APPLICATION NO.	FILING DATE	FIRST NAMED INVENTOR	ATTORNEY DOCKET NO.	CONFIRMATION NO.
09/760,593	01/16/2001	Toru Ishii	P/2007-76	4296

**Advisory Action
Before the Filing of an Appeal Brief**

THE REPLY FILED 06 September 2005 FAILS TO PLACE THIS APPLICATION IN CONDITION FOR ALLOWANCE.

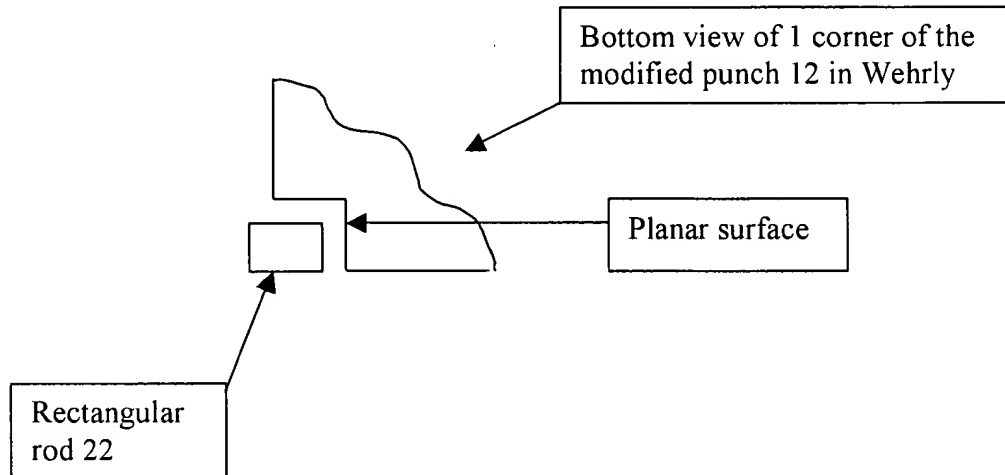
Applicant argues that the modified alignment system of Wehrly et al. does not meet the limitations of the claims since the alignment rods contact the punch at a corner edge, not on a planar surface. Examiner respectfully disagrees. The alignment rods contact the punch at a planar. See the below sketch.
